# 2nd Gen Indoor Station Firmware V2.1.40\_build220428 Release Note (2022-05-13)

Device Model	DS-KH8350-WTE1、DS-KH8350-TE1、DS-KH6320-WTE1、DS-KH6320-WTE2、DS-KH6320-WTE2(B)、DS-KH6320-TE1、DS-KH8520-WTE1
Firmware Version	V2.1.40_build220428
iVMS-4200 Version	Latest version
Hik-Connect APP	Latest version

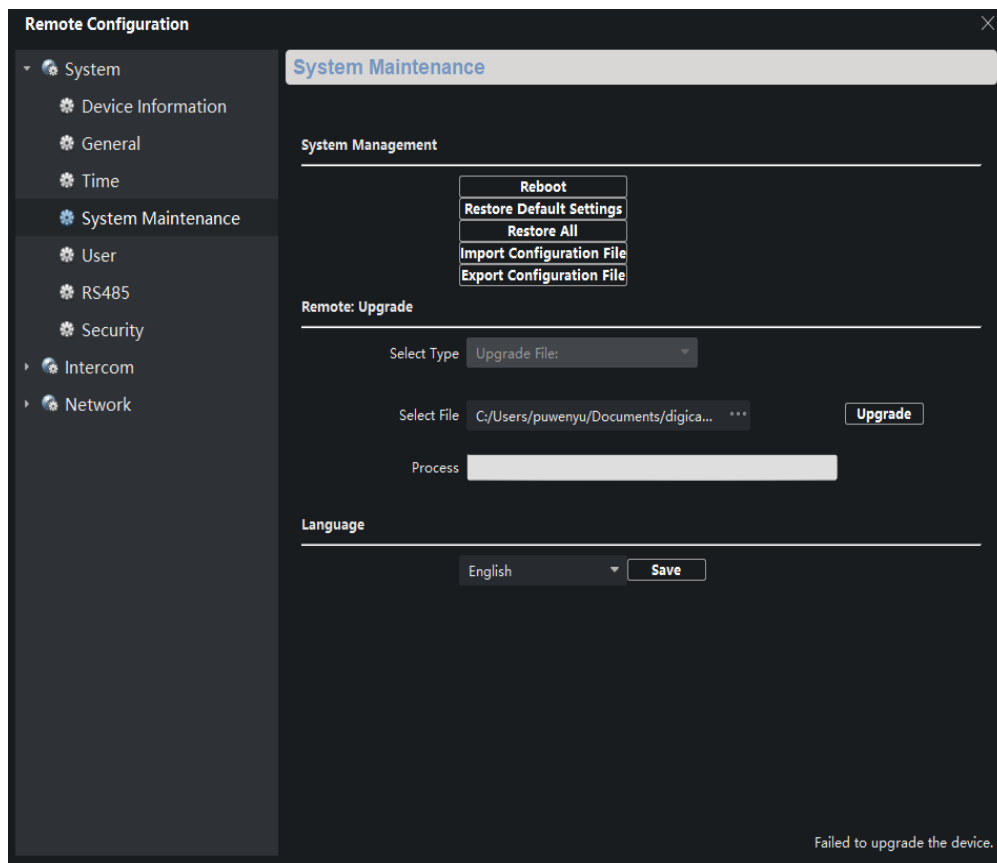
1、 **Since V2.1.24 build 210617, remote degradation of devices is not supported in all subsequent versions.** When degradation occurs, it will prompt Failed to upgrade the device and the device will restart.

**Notice: Although the device can be degraded by serial port, the device will fail to start and cannot change the version by using serial port again, which means that the device will be completely unusable.**

## Wizard-Hik-Connect Service Settings 4/5

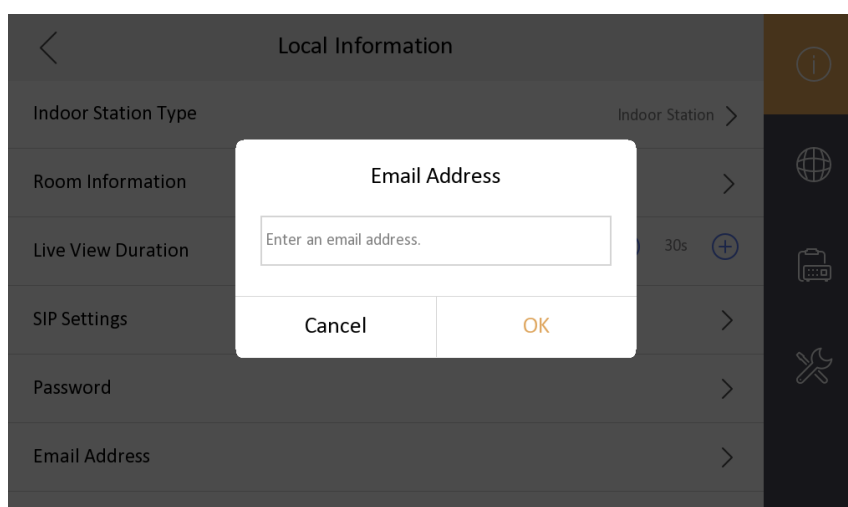
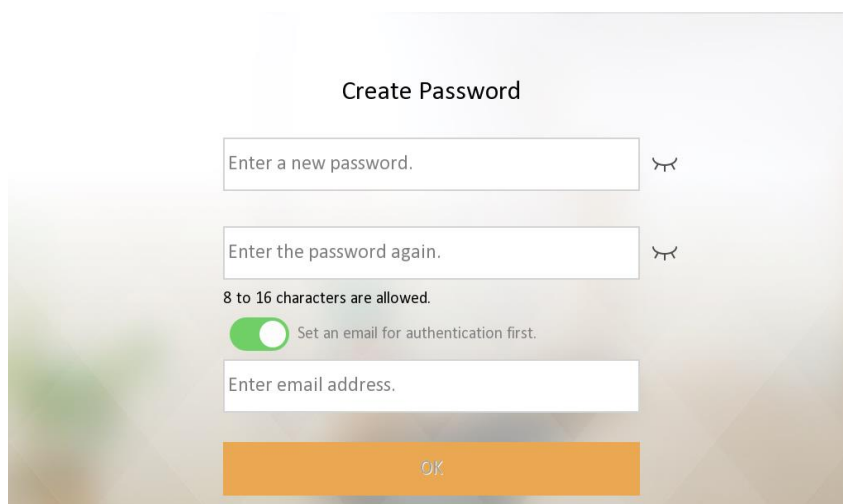
2. Support Hik-Connect configuration, closed by default

## Add Device

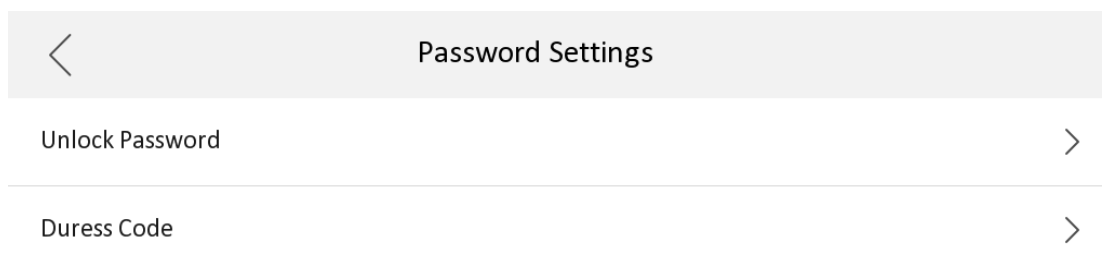
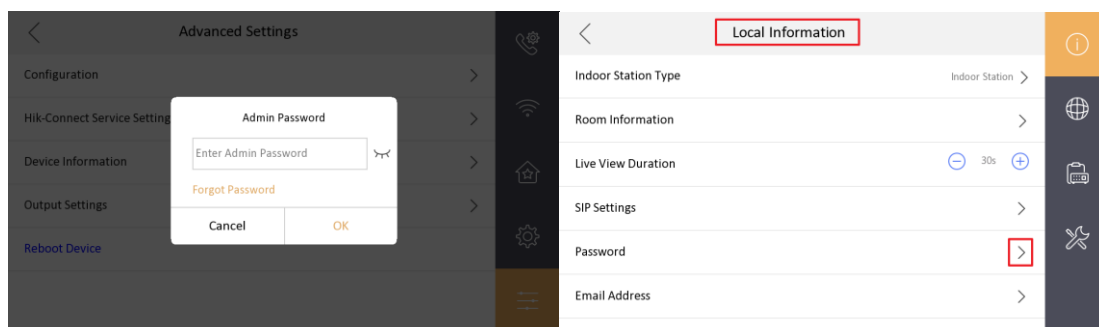
3. Newly added multi-language Croatian, Dutch, Romanian, Czech, Bulgarian, Croatian, Serbian
4. Add IPC interface, when Open Network Video Intercom protocol is selected, add plaintext ciphertext switch menu item configuration

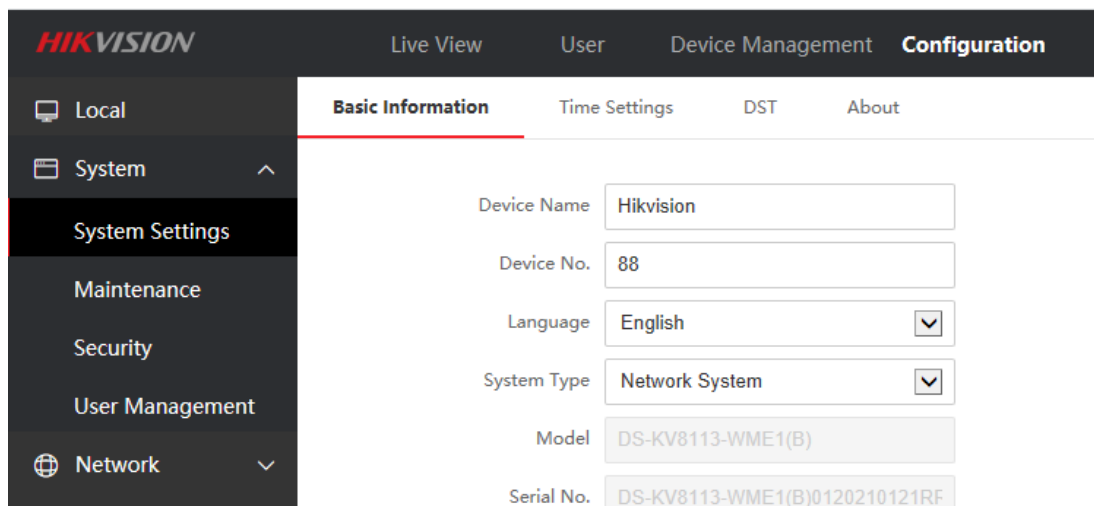
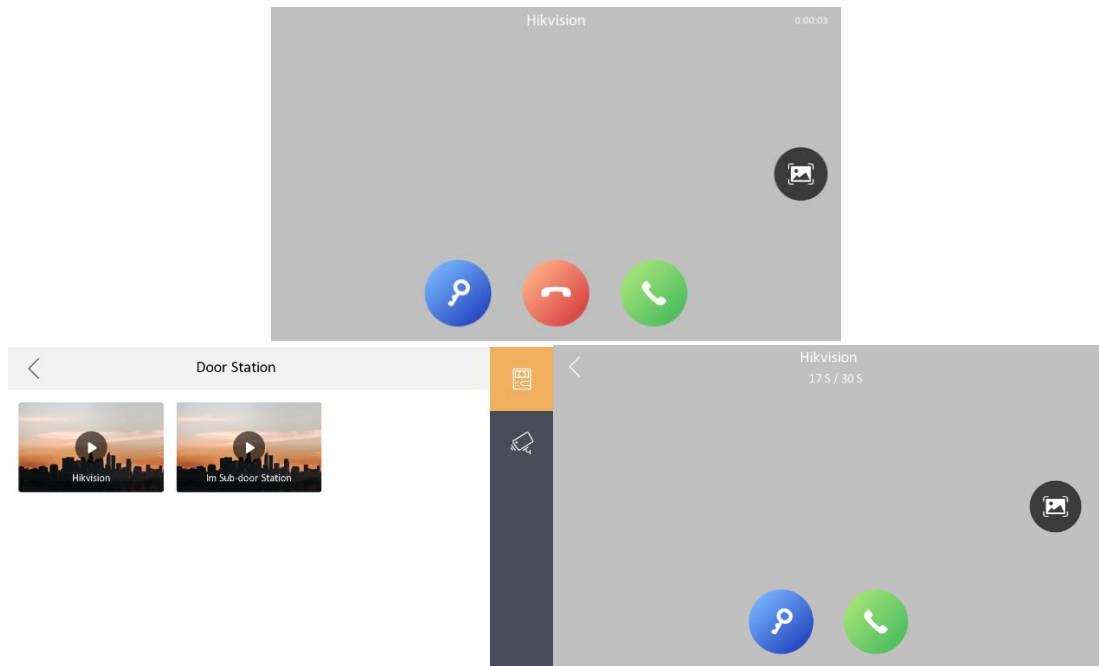
1. Change the position of unlock password and duress code, to enter the password page requires an admin (activation) password.

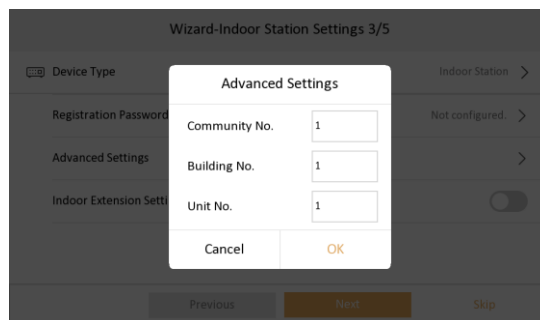
2. When changing the unlock password and duress code, the old password is not required as a credential.
3. The name of the local private SIP password configuration Sip Password is uniformly changed to Registration Password
4. The changed name of the door station(KD8003 modular door station, KV(-B), KB8113) will be displayed on the call interface or live view interface of the indoor station

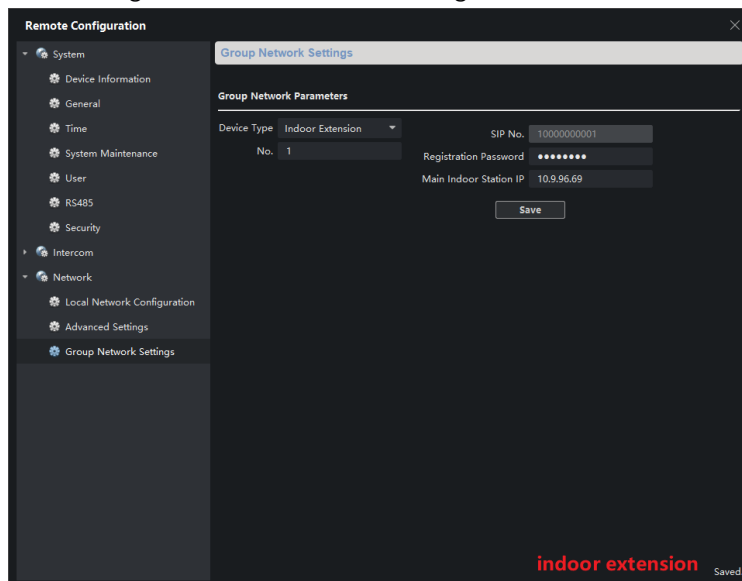
- The local interface community number, building number, and unit number of the indoor station will be stored in the advance column instead of being displayed directly

SIP register password

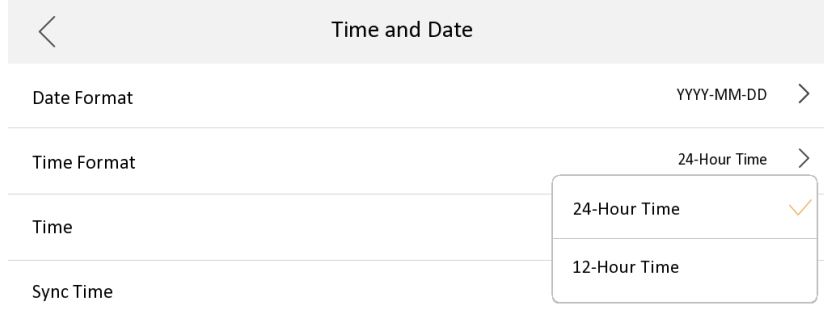
#### 1. Higher security, SIP Passwords (Register Passwords)

SIP password is actually Register Password, which is suitable for our security 2.0 protocol. They can communicate normally only when the **SIP passwords (Register passwords)** of the door station, indoor station and indoor extension are the **same**.

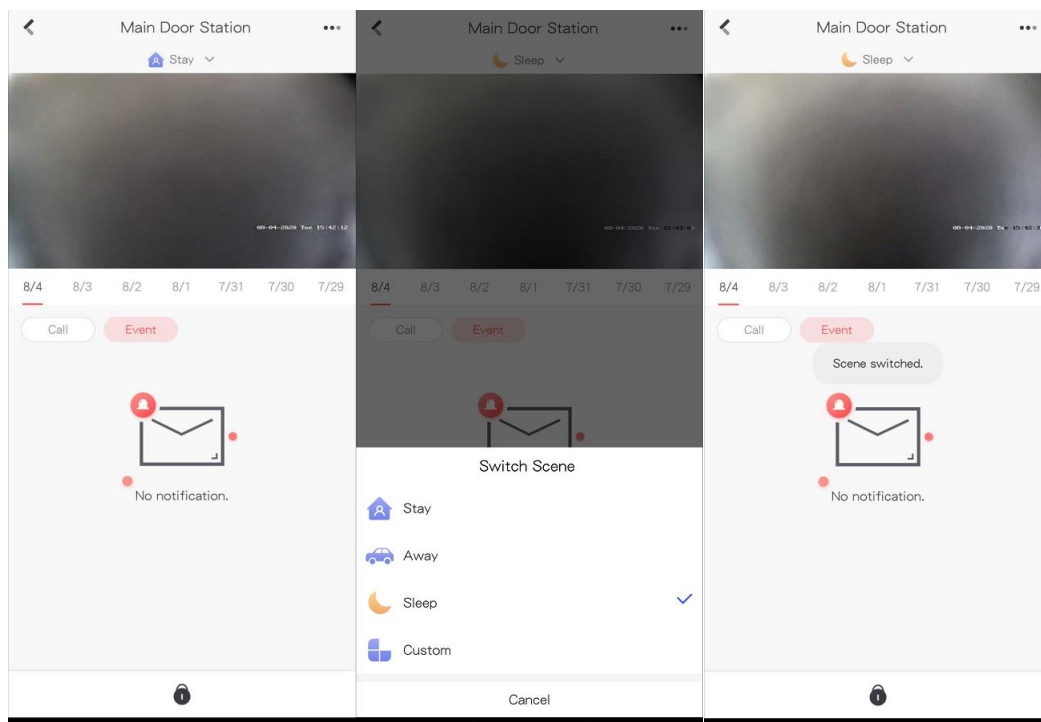
3. Multi-language added to 12 countries: English, French, Portuguese (Brazil), Spanish, Russian, German, Italian, Polish, Arabic, Turkish, Vietnamese, Ukrainian.

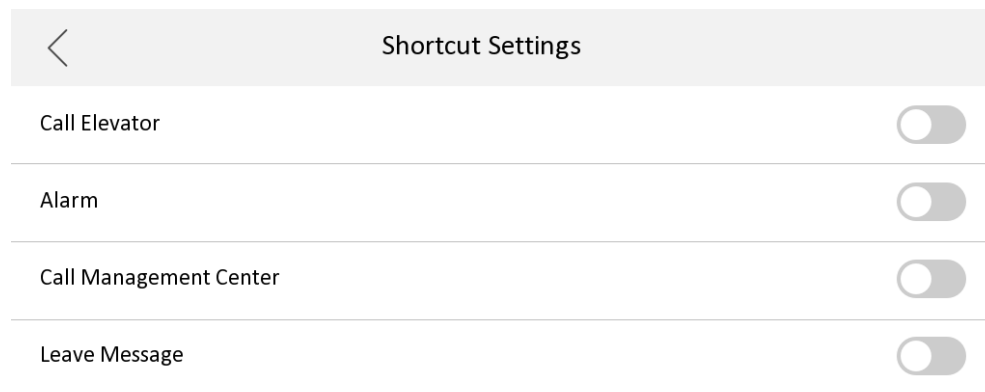
5. Support whether to enable the call management center function, it is disabled by default

6. Support whether to enable the leave message function, it is disabled by default

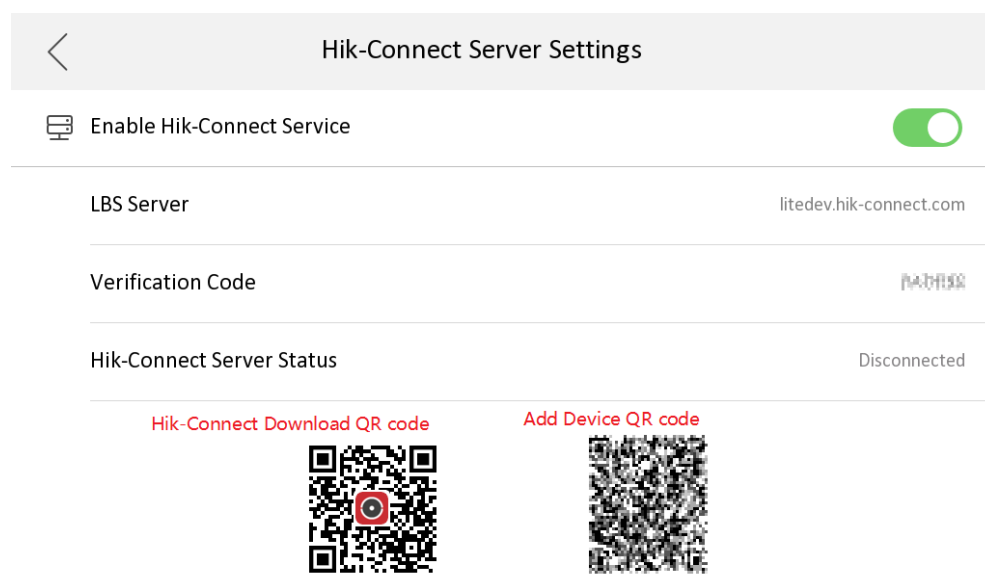
1) In the Settings->More->Preference->Shortcut Settings interface

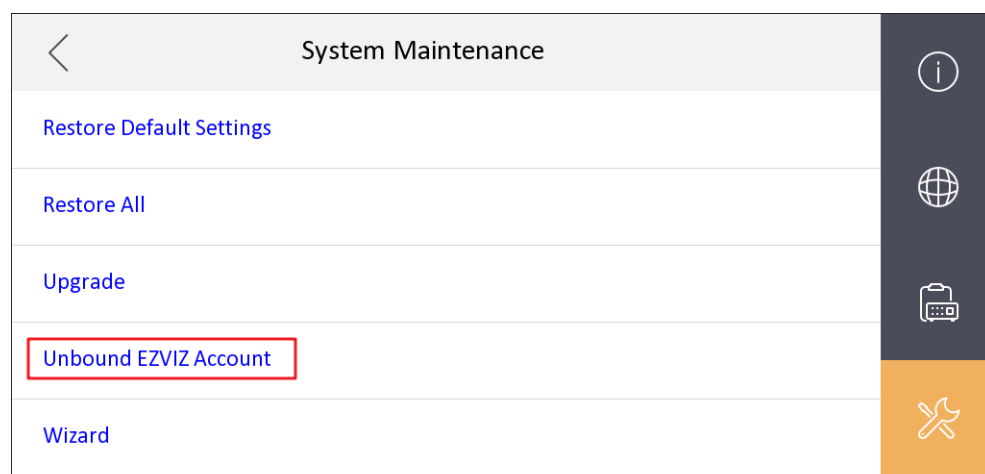
7. Add the QR code of Hik-Connect App download address to the indoor station Hik-Connect configuration interface

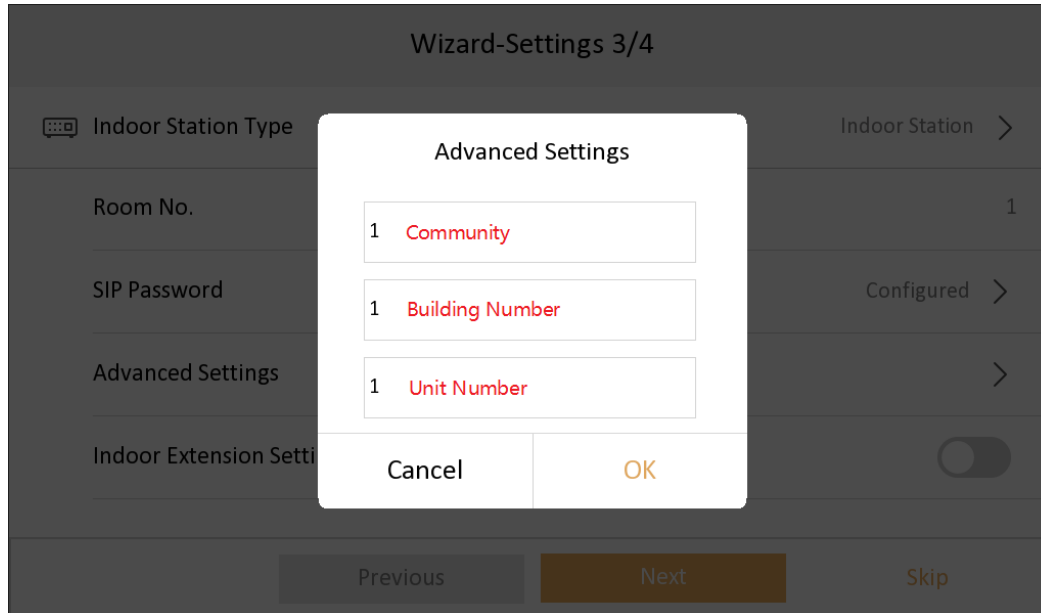
The communication protocol between Hikvision devices uses a secure private call protocol, and the communication with 3<sup>rd</sup> party devices uses standard SIP;

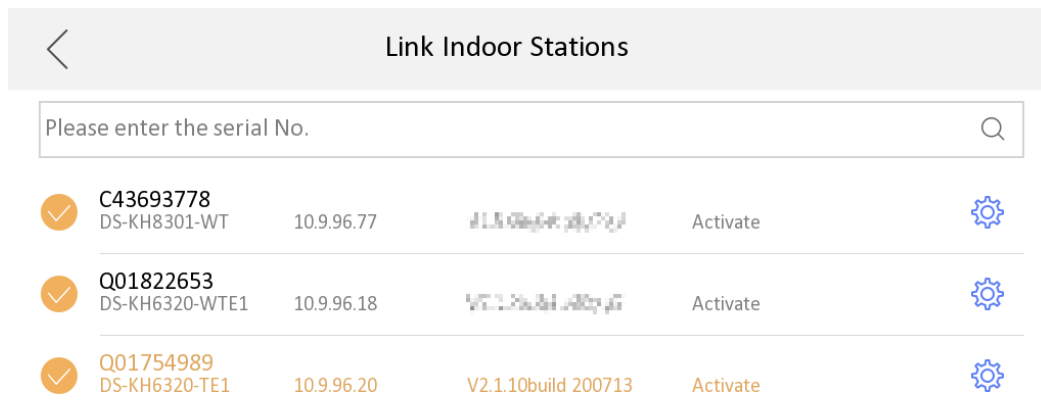
1) Support setting period number, building number, and room number on the indoor station;

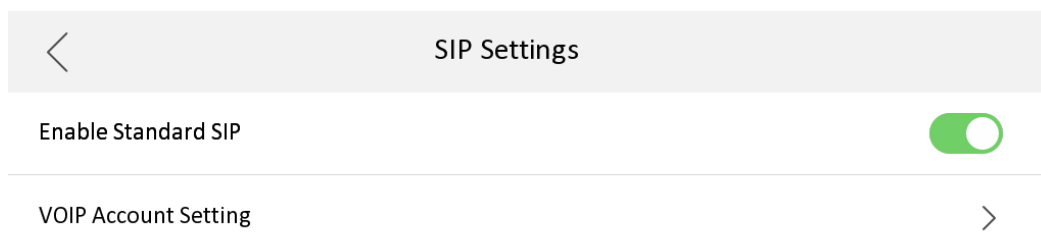
a) The indoor station does not need to switch to SIP mode;

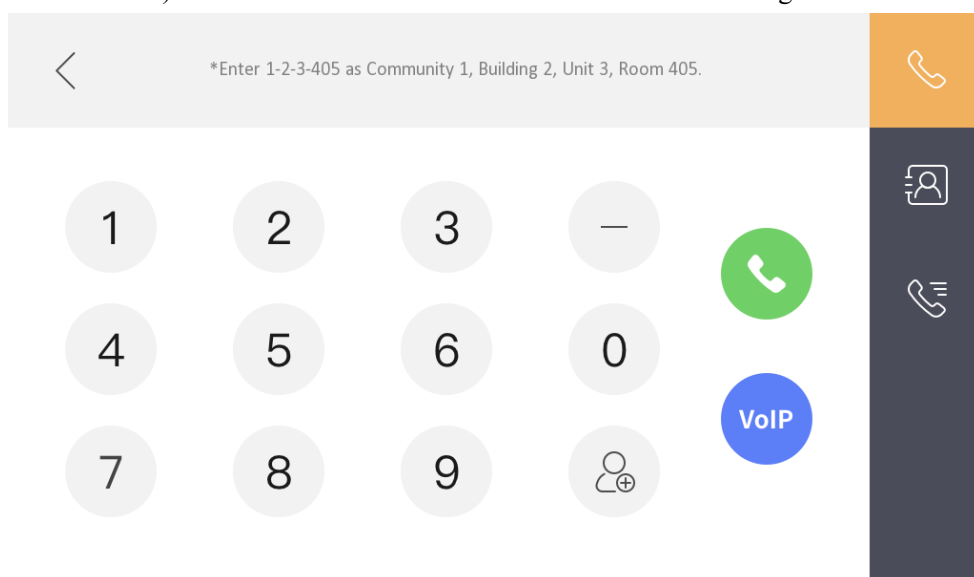
c) A standard SIP registration status icon is added to the main interface, which can be displayed/hidden according to whether standard SIP is enabled;
